PRELIMINARY DESIGN APPROVAL
ALTERNATIVE SYSTEM

Property Address: 229 Basswood Drive Town Silver Lake
Applicant: William Dennis/ Timberland Management Inc.
Designer: William G. Dennis
Address: P.O. Box 659
Kelso, WA 98626

Alternative System: Sand Filter

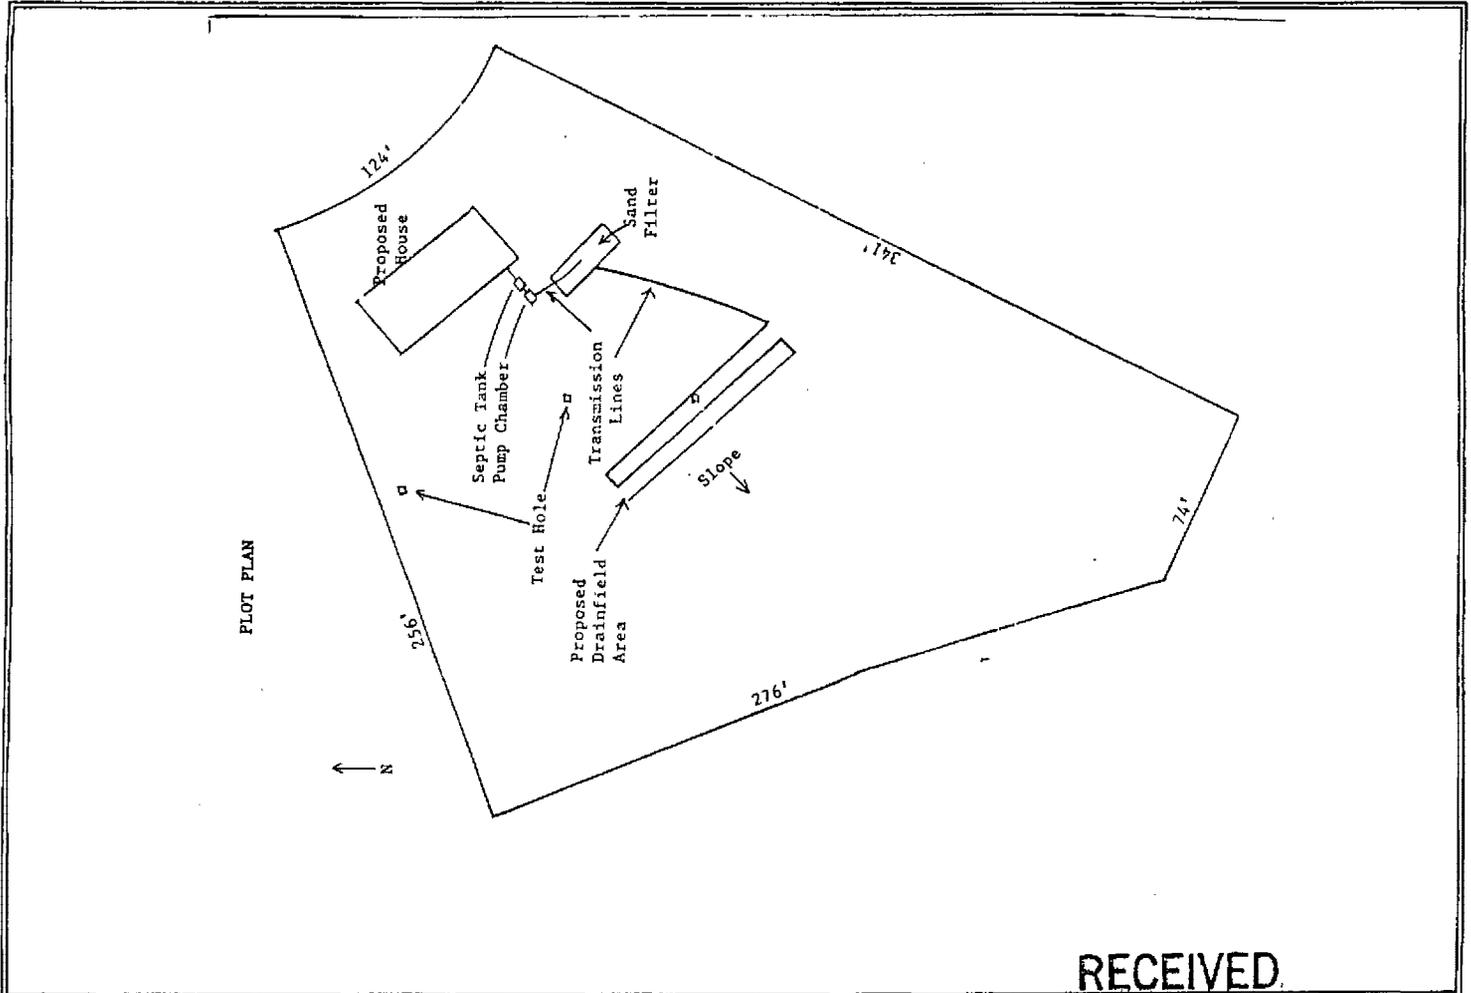
RECEIVED COMMENTS: Holes show signs of frequently having water in them. Drainage
BLDG. & PLAN curtain needed.
